Service Bulletin

Priority Level: Low — Useful Information		
Attention:	All Service Personnel	**Bulletin:** SB-032 **Date:** 2/7/2007
Products:	*Need for Speed*™ **Underground**	
Issue:	Shifters need adequate slack in micro switch wires.

Shifter Assembly with Broken Micro Switch Wire

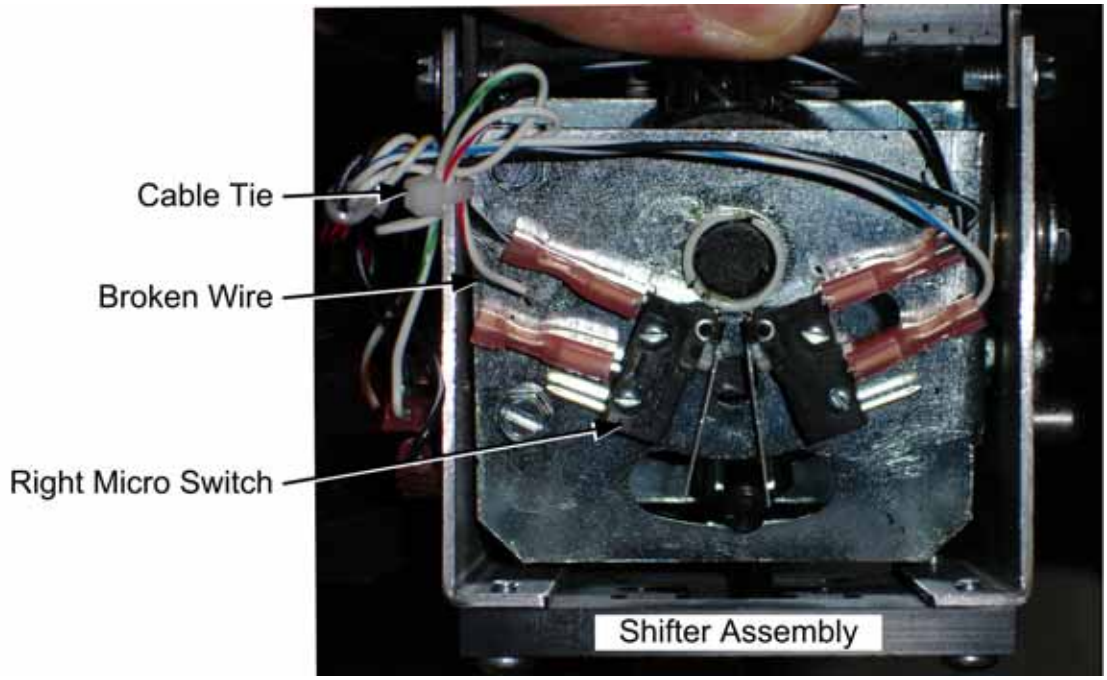
Symptom: Some six-speed shifters were shipped with wires tied too tightly near the micro switches. This can cause the wires to the *Right* micro switch to break, causing the shifter to malfunction in gears 5 and 6.

1. Remove the four (4) T-10H Torx® Security screws from the top of the shifter assembly and carefully lift the shifter assembly out of the housing.
2. Inspect the wires while moving the shifter left to right, and make sure there is some slack in the wires between the cable tie and the switch terminals.
3. If necessary, snip the cable tie and re-tie it so that there is adequate slack in the wire.
4. If the wire has broken, splice it to a new spade connector and make sure there is adequate slack in the wire when you connect it to the micro switch.
